Legon Fire Station Child Lab and E A Boateng Road Reconstruction Brief

Correct the selected area in the existing University of Ghana bicycle exploration game using 14 paired street comparisons, three annotated real aerial maps and six game overview references. The principal task is to replace unsupported tall institutional templates with the observed low buildings, yards, roof forms and connected road landscape. This brief follows the supplied sample format and addresses this new section only.

Pair 1

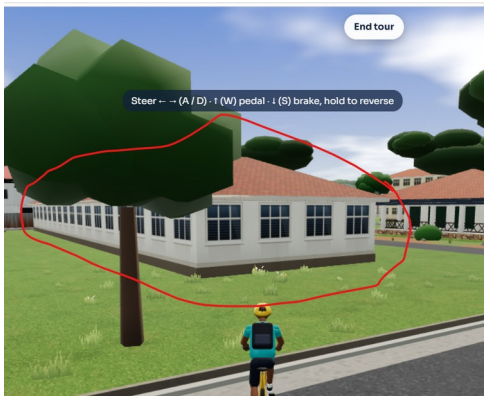
The marked game target is a tall, regular multi-storey block behind the veranda building. The real marked target is a low white wing with a long red roof, small dark openings and mature trees close to its facade. The height, window density and roof hierarchy are wrong. Sparse game planting also exposes buildings that the real canopy partly conceals.

The real foreground pavilion has a broad tiled roof, projecting gabled veranda, pale columns, dark glazed openings and a stone-faced raised base. A lower adjoining or neighbouring roof sequence continues behind and to the right. The blue outline identifies that low sequence, not every building in the photograph. Hedges, flower beds and trunks layer the frontage.

Use R1 to trace the outlined courtyard complex, its perimeter wings and internal cross paths. Keep the courtyard open; do not fill it with a taller block. Remove the unsupported extra storeys in the marked sightline, fit the long wing roof and opening rhythm, and retain the veranda as a distinct projection. Verify roof joints against R1 rather than merging all visible roofs into one pavilion. Fit window and column widths after matching the camera.

Keep the veranda floor and stone plinth above the immediate garden ground, with only supported access level changes. Rebuild the road curb, narrow verge, layered hedges and mature irregular canopy. Connect the courtyard edge and opposite roadside building to Pair 2 through R1; do not duplicate either complex.

From the Pair 1 camera, the outlined background reads as a low wing beneath the trees, while the foreground veranda retains its columns and raised base. No invented upper-storey window grid rises above that wing. Confirm the same footprint in the overhead render.

Pair 3

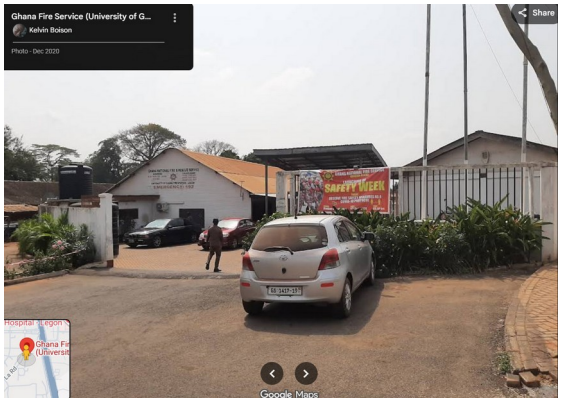
The game replaces the station with three-storey and two-storey classroom-style masses and repeated large windows. The real view shows low gabled service buildings and a thin open-sided canopy. Missing boundary walls, the water tank and yard geometry change both silhouette and function.

A pale gable on the left carries fire-service lettering behind a ribbed black elevated water tank. A second low pale gable stands to the right. Between them, a broad dark metal canopy on slender posts covers a red fire engine and part of the vehicle yard. A weathered pale wall with metal railing encloses planted ground at the front.

Use R3 to locate the station parcel and the Pair 3 direction. Replace only the station assets with individually traced low roof volumes. Model the canopy as a thin sloped or shallow pitched sheet with visible supporting beams and open sides, not a solid building or another storey. Put the tank on its visible support and preserve its separation from the gable. Reproduce only legible fire-service wording; do not fabricate obscured numbers.

Build a hardstanding vehicle yard, planted boundary strip, wall base, entrance curb transitions and practical vehicle clearance. Subtle weathering belongs on the wall and roof edges. Keep the yard approximately continuous at access level unless additional ground evidence establishes a larger step.

Pairs 3, 4 and 5 must show the same two gabled buildings, tank, wall and canopy from their different angles. No two- or three-storey classroom facade remains at the station target. The canopy is visibly open and a vehicle-sized access reaches it.

Pair 4

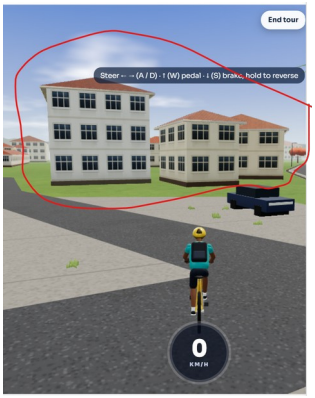
The game entrance leads across open grass to tall regular blocks and lacks the real enclosure. The exaggerated building heights, broad blank setback and simplified parking erase the reference entrance, wall corners and foreground paving.

The real entrance opens between pale boundary piers and low walls topped with dark metal bars. The gable on the left and canopy farther back define a compact working yard. A banner is attached near the right side; a utility pole and overhead lines cross the view. The foreground combines asphalt or worn hard ground with a block-paved pedestrian edge.

Use R3 and the Pair 4 arrow to place the real road mouth, entrance piers and boundary returns. Reuse the station and canopy from Pair 3, retaining the same roof corners and relative depths. Replace the large invented entrance arrangement with the visible piers, bars and opening. Add the banner as a panel with readable major words only where supported. Do not use a floating game destination label as a physical gate sign.

Fit the driveway to the existing road and yard without floating curbs or a lawn strip through the entrance. Match the right-hand paved edge, worn ground, nearby planting and pole offset. Cars and people are removable scale props; establish the gate and circulation with them hidden.

A bicycle-height entrance render shows the low left gable, open canopy behind it and the correct pier-and-wall opening. Turning into the supported access reaches the same yard as Pair 3. No added step blocks the driveway and no roof intersects the gate.

Pair 5

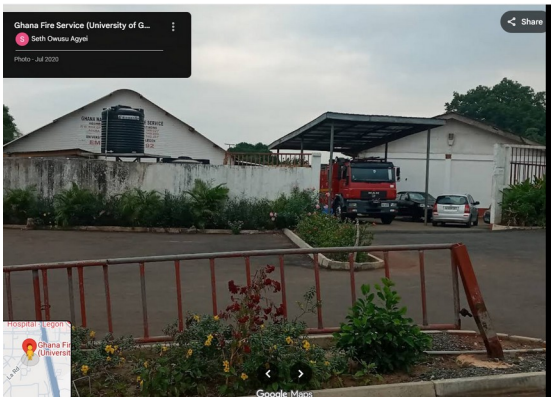
The game again presents a tall classroom group and open lawn. It omits the actual station enclosure and the low foreground metal barrier, while using parked cars as a substitute for the service-yard layout.

This real photograph repeats the station gable, tank, pale boundary wall, fire engine and open canopy seen in Pair 3. Its distinct framing adds a low reddish metal railing across the near foreground, planted flowers at its base and a hard street or forecourt surface. Mature trees sit behind the low roofs.

Treat Pair 5 as another observation of the existing station, not a second fire-station asset. Use R3 for its direction and relative viewpoint. Keep the gable lettering, tank position and canopy supports consistent with Pairs 3 and 4. Add the foreground railing as thin uprights and horizontal rails only where the street/map alignment supports it. Its span must not become a fence across the station driveway.

Replace the open green game forecourt with the evidenced asphalt or paved surface and planting strip. Retain gentle local curb transitions; the photograph does not establish a deep ditch or large terrace. Use weathered pale walls and dark canopy sheets, avoiding the game-wide bright terracotta hip-roof material.

The saved camera shows the same station roof ensemble and tank as Pair 3, with the low railing correctly nearer the viewer. With vehicles hidden, the enclosure and canopy still explain the scene. A route between Pairs 4 and 5 must not cross duplicate walls or contradictory entrances.

Pair 6

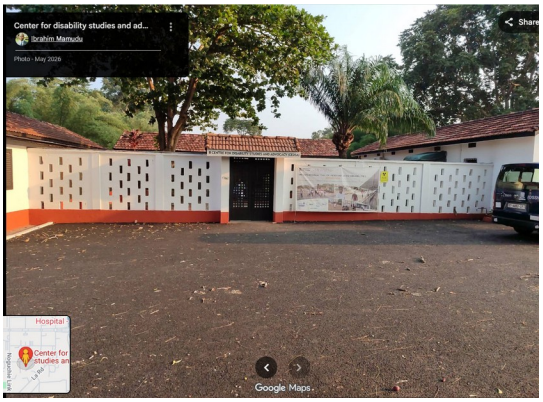
The game substitutes a two-storey hip-roof block and rows of large windows for a small low service office. Its car grid, continuous lawn and missing pedestrian surfaces hide the real doorway, barred windows, hedged access and street hardware.

The real near office has an off-white facade, muted reddish-brown lower band and low dark roof edge. A tall pale door and barred windows face the paved edge; exterior air-conditioning units sit below openings. Several short posts carry alternating pale, red and dark paint. A hedge-lined access leads toward a longer low roof behind a large tree, and overhead wires reach a near pole.

Locate this frontage with R3 and the Pair 6 direction. Model the near office as a low separate mass, not a scaled-down multi-storey classroom. Place only the visible door, window bars, AC boxes and roof edge. Trace the longer rear roof independently from the aerial; do not extend the near office into an invented continuous upper floor. The pale vertical sign frame can remain blank if its wording is not readable.

Lay block paving along the office frontage and rougher compacted or asphalt access beside it. Put bollards outside the clear route and make the hedge turn reveal the actual access gap. Keep the office base attached to its ground; avoid a sudden grass shelf or deep drain unsupported by the image.

The view reads as a low office with barred windows and AC units beside a hedge-lined access. The station compound remains consistent with Pairs 3-5 and the long road view in Pair 14. Posts, pole and curb allow the supported bicycle route to pass.

Pair 13

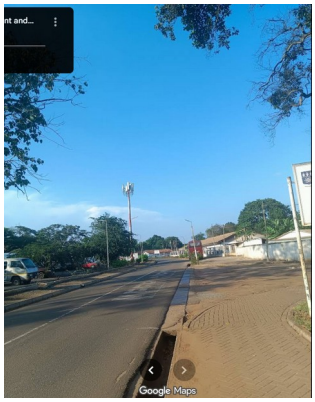
The game presents a plain low white wing surrounded by open grass, with few planted edges and no correct directional sign. The reference is a close, shaded entrance landscape beside the same low building family.

A freestanding pale CEGENSA direction sign on slender posts dominates the near left foreground. Its red arrow points right. Behind it, the low white wing has a red base, dark louvred windows, reddish roof and exterior AC units. Mature trunks and smaller palms sit in patchy grass; a pale curb separates the garden from irregular stone paving on the right.

Use R2 and the Pair 13 arrow. Reuse the verified CEGENSA wing and corner geometry from Pairs 9-11 rather than placing another copy. Build the real sign as a physical panel on posts, preserving the visible CEGENSA wording and arrow orientation; omit unreadable contact details instead of inventing them. This physical sign is different from a map arrow or game HUD marker.

Reconstruct the curb-lined stone path, patchy garden, mature tree trunks and modest soil/grass height change. Preserve the route continuing along the building and the gap beyond it. Trees should shade and partly obscure the facade while leaving the sign legible. Keep the AC units attached to the visible wall.

The Pair 13 camera shows the sign to the left, arrow pointing right, building behind it and paved route to the right. The route connects to the courtyard and R2 road layout without overlapping walls. Verify the sign is placed once and its arrow is not converted into a ground object.

R1 Real aerial courtyard complex and Pairs 1 and 2

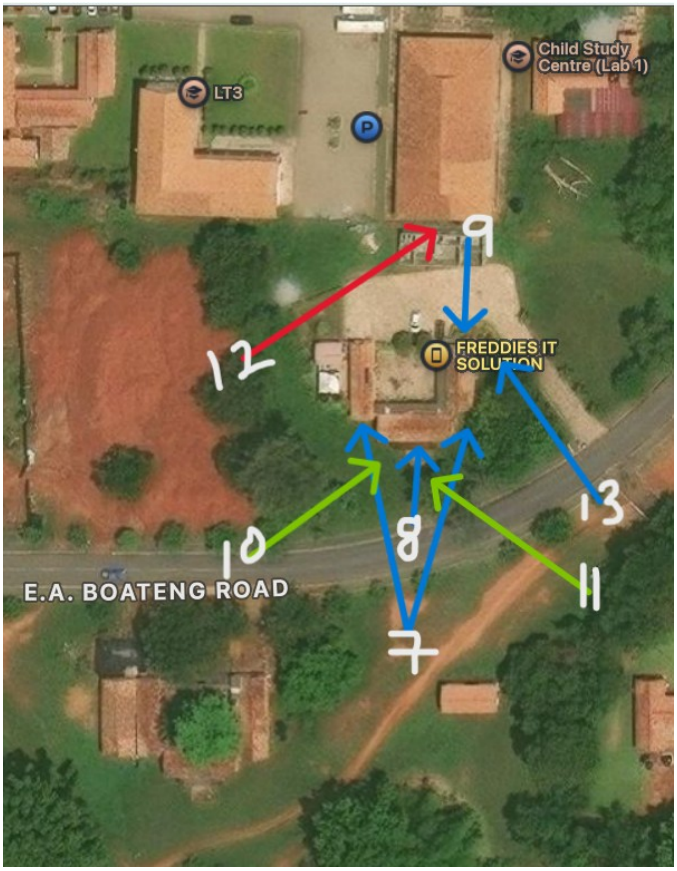
The blue outline encloses a perimeter-roof courtyard with an internal cross of paths and four green quadrants. The green outline identifies a separate long roof on the other side of E A Boateng Road. The numbered arrows assign the Pair 1 and Pair 2 viewing directions. Those two targets must remain distinct; the screenshot does not authorize placing a tall block inside the courtyard.

Trace visible roof extents, courtyard openings, cross paths, road separation and tree masses before elevation work. The larger unoutlined roof below the green target and the adjacent drama-studio roofs are neighbouring masses, not automatically extensions of the Pair 2 building. Use the street views for local facade detail and height, and the aerial for overall plan relationships.

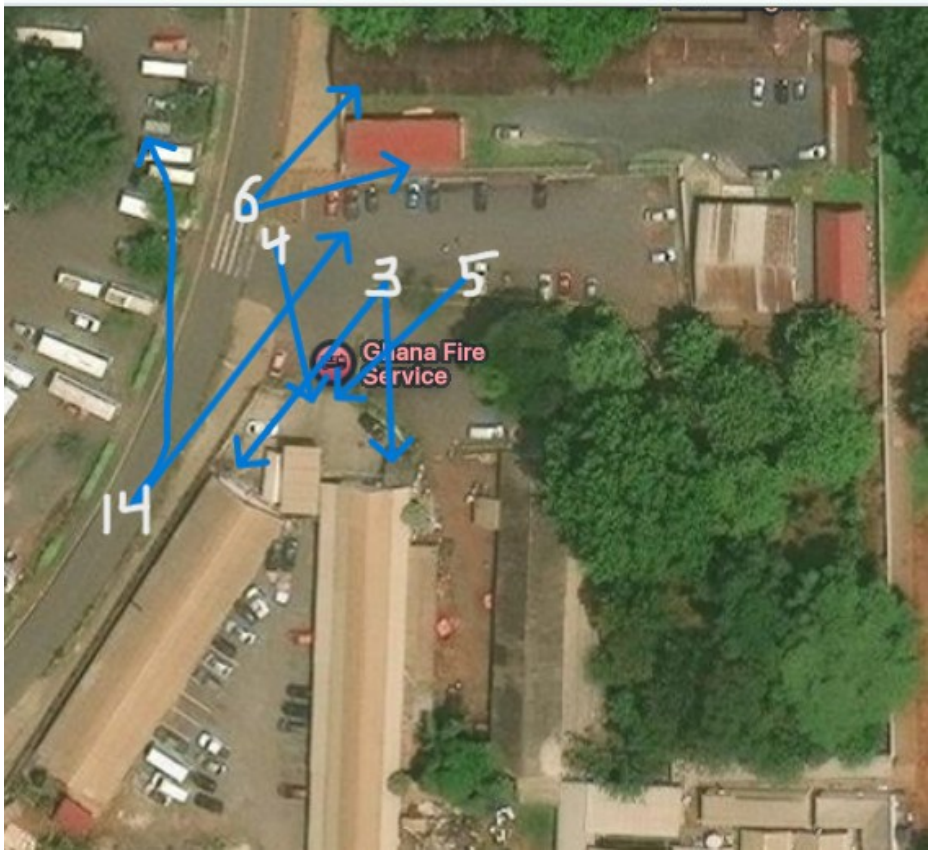
The map shows E A Boateng Road curving across the lower part, a compact irregular roof-and-court cluster inside the bend, a long roof toward the upper part, the neighbouring LT3 footprint, an open reddish parcel and substantial vegetation. Separate arrows are assigned to Pairs 7, 8, 9, 10, 11, 12 and 13. The Child Study Centre label is a regional anchor, not proof that every arrow addresses that building.

Use the arrow tails as approximate viewing zones and follow their heads to the relevant facade or courtyard. Reconcile CEDSA gate views with the CEGENSA gable and courtyard views through roof corners and street evidence; do not merge their institutional identities. Keep the Pair 12 outward sightline toward the long block distinct from the close courtyard cameras. Retain the open parcel and local tree masses rather than filling all gaps with classroom templates.

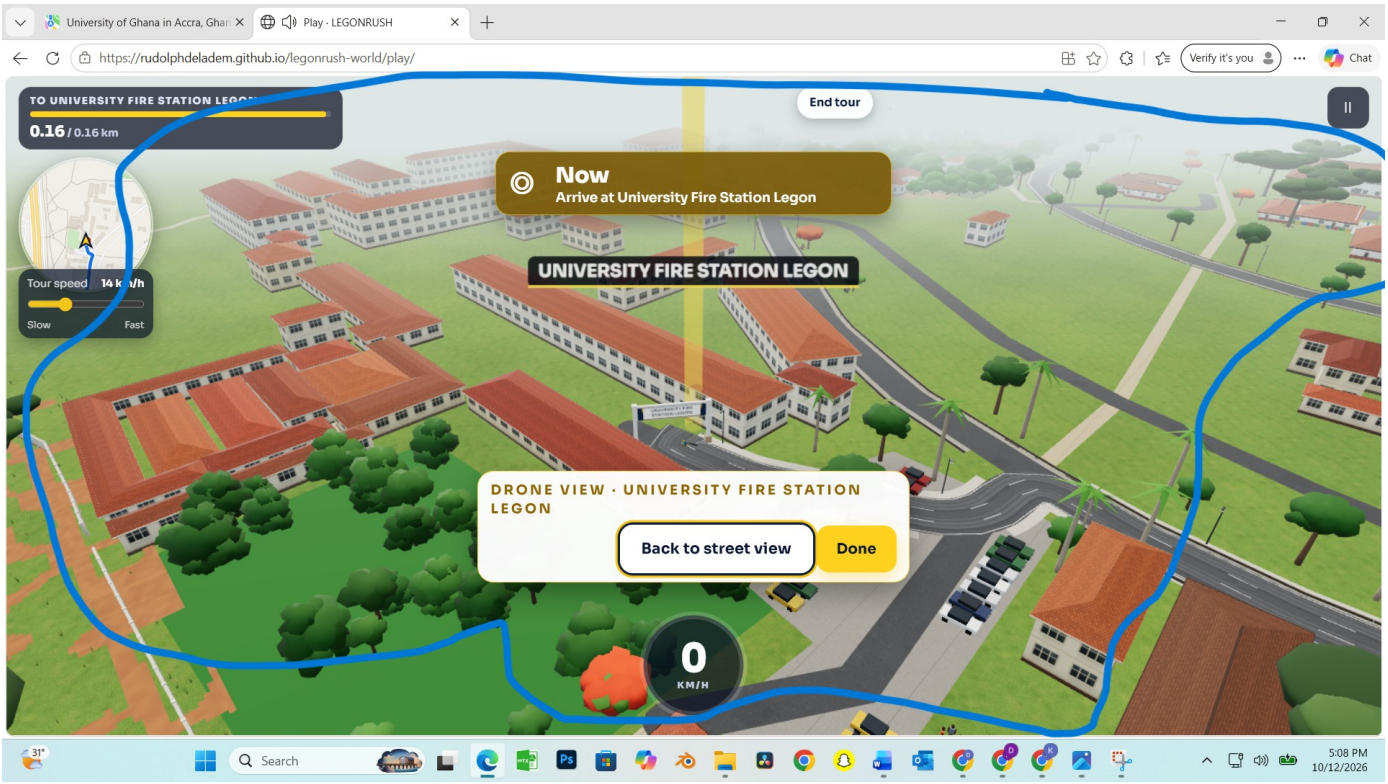
The station vicinity has a road along the left edge of the displayed map, elongated neighbouring roofs, smaller service roofs, paved or compacted yards, parking and a dense tree mass to the right. The numbered arrows assign Pairs 3, 4, 5, 6 and 14; some arrow lines cross. Crossing lines are annotations, not site boundaries or connected roads.

Align the road and station access first. Trace the selected low gabled buildings, canopy and office against Pairs 3-6, while retaining neighbouring long roofs as separate objects. Use Pair 14 to check the forward corridor, wall sequence and road margin. Keep yard access, roof setbacks and the wooded patch coherent from every camera. Where overlapping arrow heads make a precise station sub-object ambiguous, resolve it from the gable, tank and canopy in the street photo before assigning an object ID.

The corrected overhead must show one compact station service group and its working yard, with the surrounding elongated roof blocks and planted area in their supported locations. Do not turn all long roofs into station buildings or claim a surveyed compass orientation from the screenshot. Keep every original arrow and number intact.

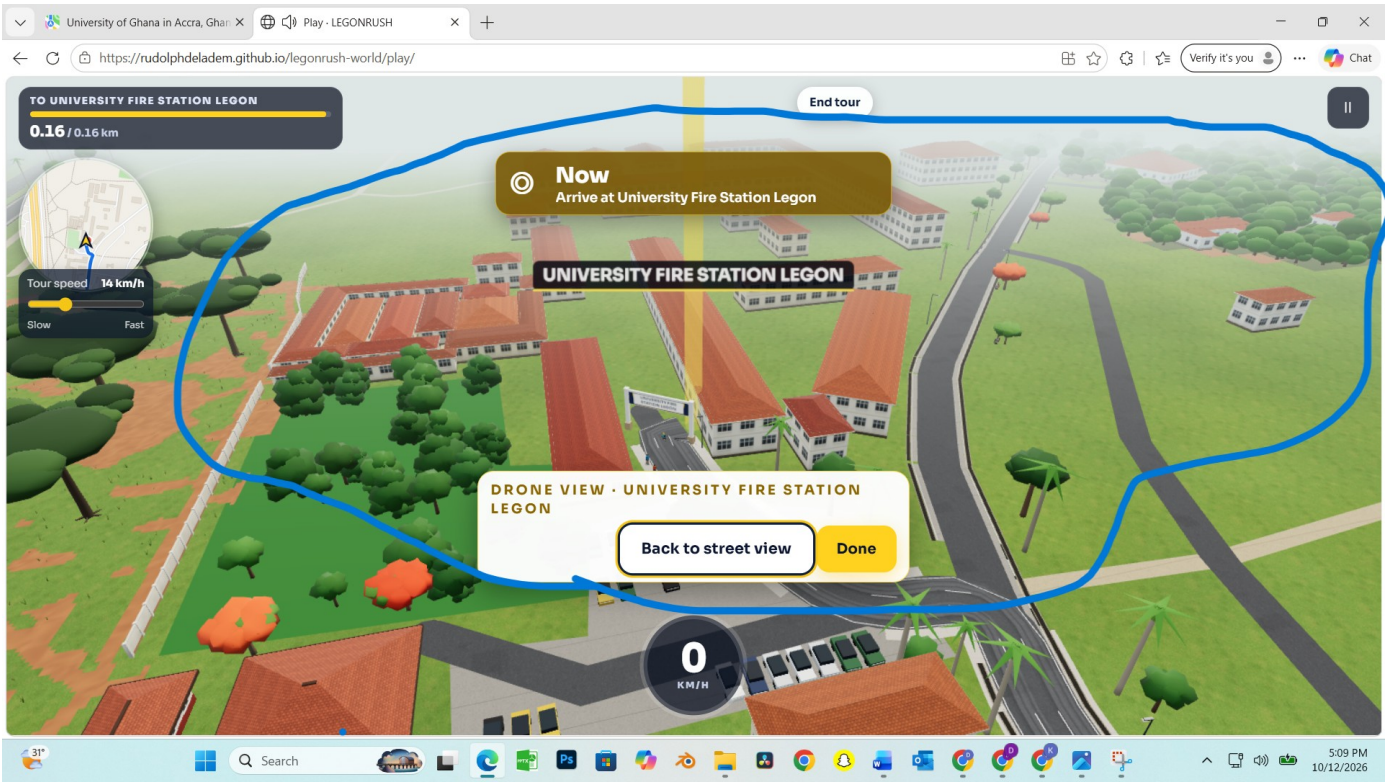
The outlined region is dominated by repeated white multi-storey blocks, long hip-roof bars, oversized lawn voids and simplified tree clumps. The station destination is represented by classroom architecture rather than the low gabled service buildings and open canopy in Pairs 3-5. Surface and enclosure differences disappear into green ground.

Register this camera to R3 using the through-road and station access, then to the wider reference layout only where overlap is evidenced. Replace the selected station template, recover yard and boundary geometry, and check each neighbouring long roof independently. Retain courtyard buildings only after their outlines and open spaces agree with the real maps. Match building massing before recolouring.

Re-render this aerial without arrival panel, destination label, yellow beam or browser UI obscuring the result. The source blue outline is a review area, not a surveyed perimeter. The corrected station is a low service ensemble with a yard; no camera-specific copy is added to satisfy the aerial.

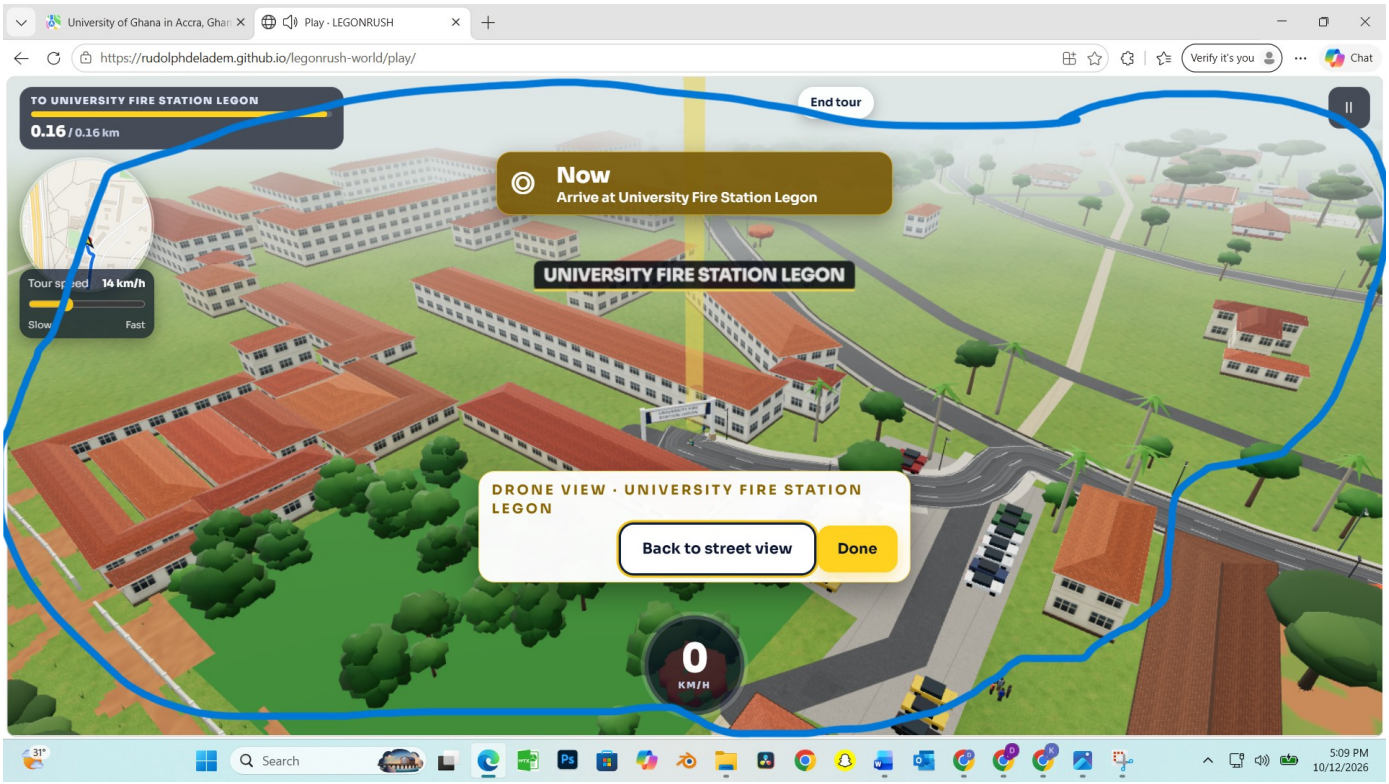
This angle exposes long, repetitive two-storey roof bars beside open lawn and an isolated small block across the road. The station marker lands among taller generic buildings. Real roof segmentation, paved yards, boundaries and vegetation enclosure are insufficiently represented.

Use this angle to test the length, orientation and separation of every replaced roof against R3. The road bend and access must join the same surfaces used by Pair 14. Rebuild low station gables, the canopy and the service office; do not merely reduce all scene buildings to one storey. Neighbouring blocks require their own roof outline and visible elevation evidence.

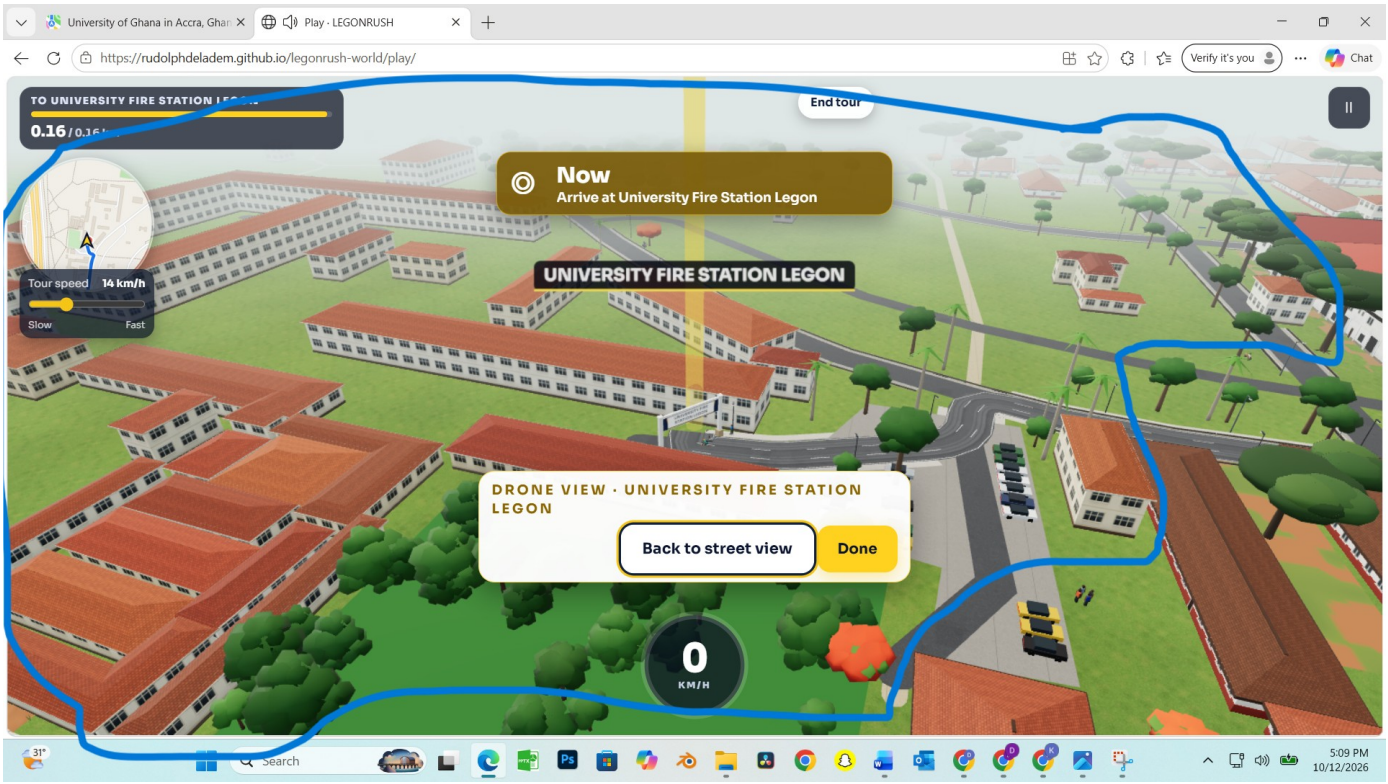
The oblique again shows repetitive long classroom bars, a large roof-and-court structure at the left and a broad paved car area near the road. A dense artificial tree patch and generic bright lawn stand in for distinct planted and service spaces. The annotation does not reveal which unlabelled game building corresponds to each real roof.

Compare repeated roof corners with G1 and G2 to identify the same assets. Test courtyard perimeter, inner openings and nearby trees against the appropriate real map after road alignment; do not assume the large game courtyard is R1 solely because both contain courts. Correct parking and ground surfaces from real evidence, keeping cars as removable props. Resolve identity before making global replacements.
